## Wiring Changes for the new Centurion (MV-3-C) display

Please observe the wiring changes below when exchanging the old C4-3 Centurion display with the new MV-3-C display:

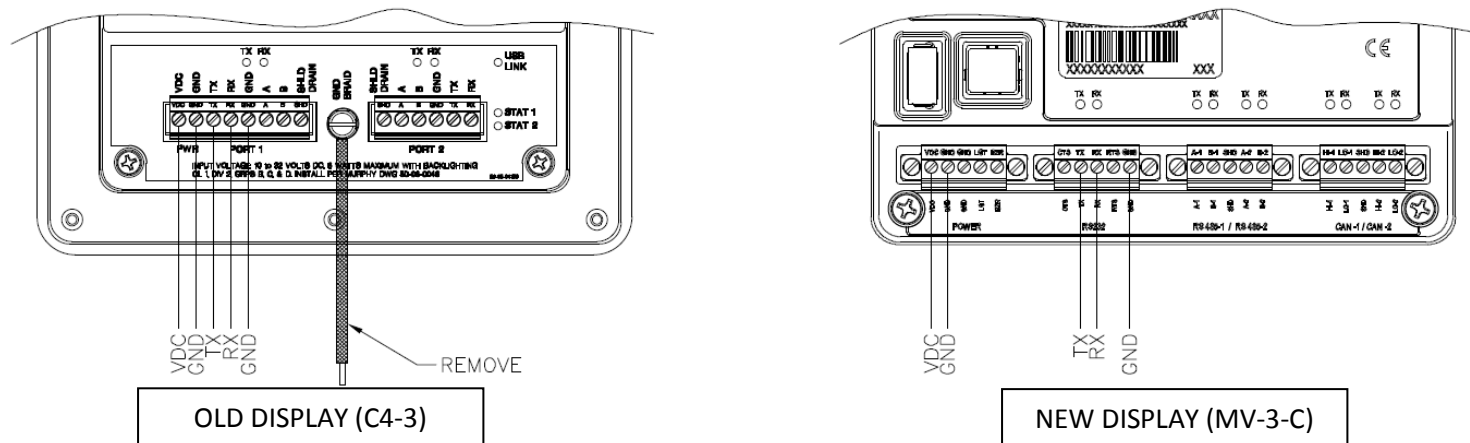
1. The wiring ports are isolated in the new display, and the connectors are held by screws. Please observe the name printed for each terminal. Example: VDC, GND, TX, RX, etc.
2. For your convenience, a screwdriver is provided with the new display to work on the terminal block screws.
3. VDC and GND for PWR terminals on PORT 1 of the old display should be connected to VDC and GND of POWER port on the new display.
4. TX, RX, GND from PORT 1 of the old display is wired to TX, RX, GND on RS232 port of the new display.
5. If you have a braided GND wire on the old display, it is no longer needed on the new display. It can be safely terminated.
6. Recycle power and the new display should start to sync with the controller.
